DATE: March 28, 2008

REVIEW TYPE: Preliminary Plan of Subdivision

PROJECT NAME: Chevy Chase Bank at Ashton

CASE #: 120070580

CHEVY CHASE BANK
AT ASHTON

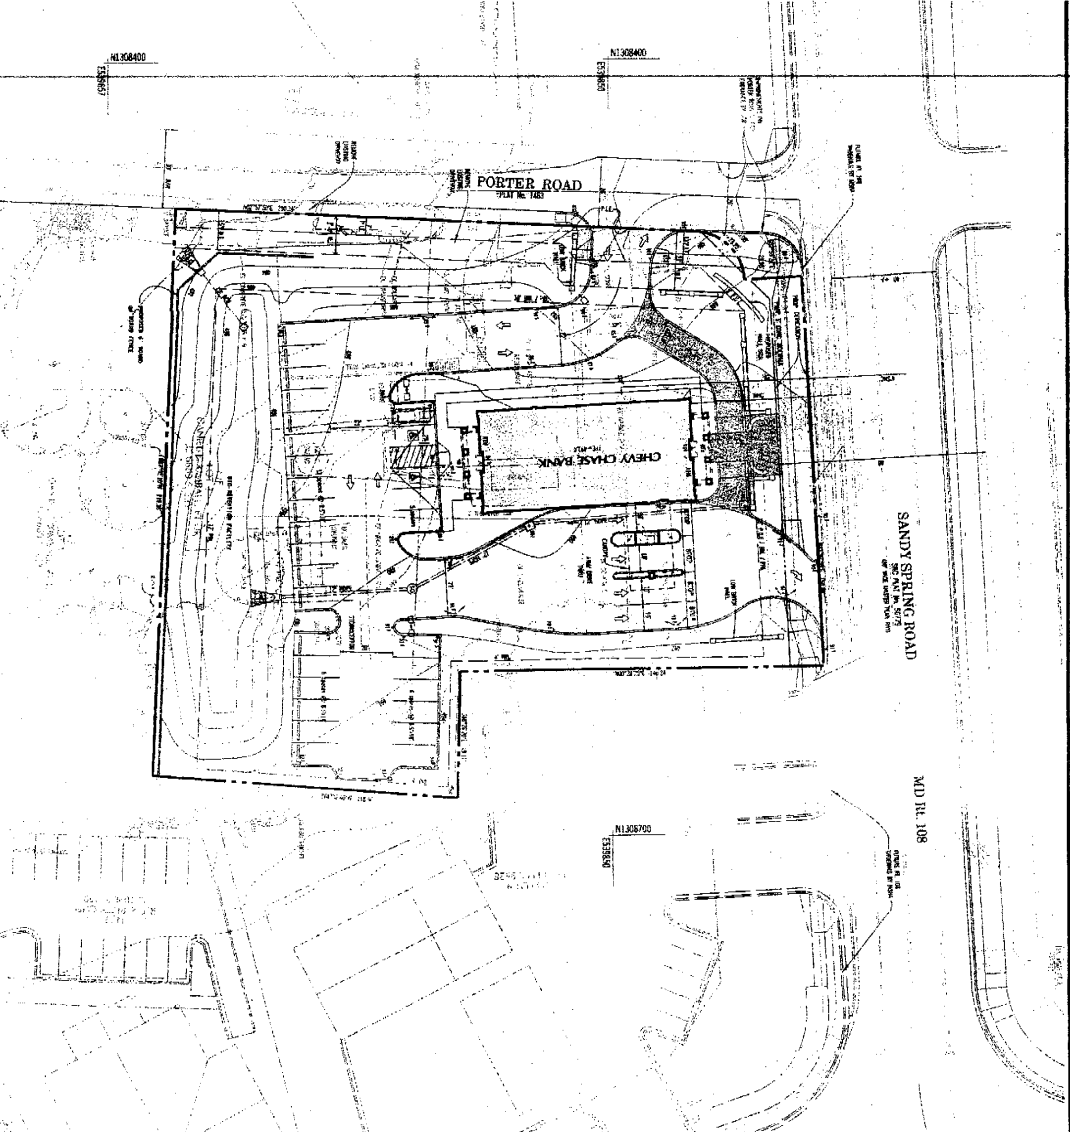
The application proposes to create one 1.05 acre lot for a proposed bank. The bank is proposed to be housed in a one-story, 3,172 square-foot building with three drive-through lanes. A driveway on Porter Road is proposed to provide access to the 30-space parking lot. An additional driveway on Sandy Spring Road (MD 108) is proposed to serve as a right-turn exit only. A bio-retention facility to hold stormwater is proposed near the southern property line.

The preliminary plan proposes inbound access to the bank from MD 108 via Porter Road, through a driveway approximately 60 feet from MD 108. Outbound traffic from the bank would access MD 108 via the Porter Road driveway as well as a right-out only driveway from the site (to eastbound MD 108). To accommodate additional site-related traffic, the applicant is proposing frontage improvements along Porter Road up to the proposed access driveway to the site, including widening of the roadway pavement to 26 feet and providing a four-foot wide sidewalk. The applicant is also required by MCDPWT as part of preliminary plan approval to execute a recorded covenant for potential future construction of Porter Road.

afforestation requirement by planting nine red maples as credit for tree cover. Staff recommends that only five of these maples be given afforestation credit. Staff does not recommend four maples be given afforestation credit because these maples will be planted within the proposed stormwater management (SWM) facility. Trees and any other vegetation planted in SWM facilities are subject to a SWM easement which allow for the removal and replacement of vegetation within the SWM facility for the purposes of any maintenance measures required by the County. Staff recommends that more native, shade trees be planted on the outside of the SWM facility for landscaping purposes on the site and that such trees be given afforestation credit. The total afforestation credit that is required for the site is 7,405 square feet. Based on the current forest conservation plan, the project has 4,535 square feet of afforestation credit for native, landscaped trees that are outside the SWM facility. An additional 2,870 square feet of afforestation credit is required by Condition 2d of the staff recommendation. As conditioned, the plan meets all applicable requirements of the county Forest Conservation Law.

- d. The applicant must revise the landscape plan and preliminary and final forest conservation plans to include native shade trees as landscape trees that will create a total of 7,405 square feet (0.17 acre) of tree canopy coverage at 20 years. These trees must be located outside of the stormwater management easement.
